April 10, 2003

Site Inspection, Jason Shumway, Picture Rock Quarry, S/037/099, San Juan County, Utah

Inspection Date: March 27, 2003; Report Date: April 10, 2003

Photo 1. Part of the graded area.

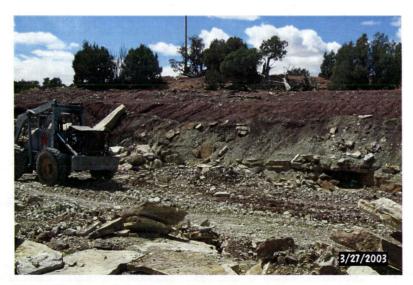
A portion of the site is basically reclaimed except for seedbed preparation and seeding (Photo 1), but the operator is still taking some stone from parts of the site nearest the road (Photos 2 and 4). Part of this area is in something of a depression.

The part of the site that has been regraded looks good. As the operations wind down, the operator will need to continue grading the site to make it blend with adjacent areas. Unless the Bureau of Land Management decides it would like the existing depression (right side of Photo 4) to remain as a watering structure, the remaining active quarry area should be graded so it has positive drainage leading off the site. Some of the material that was pushed to the side by the county could be used as fill for this area.
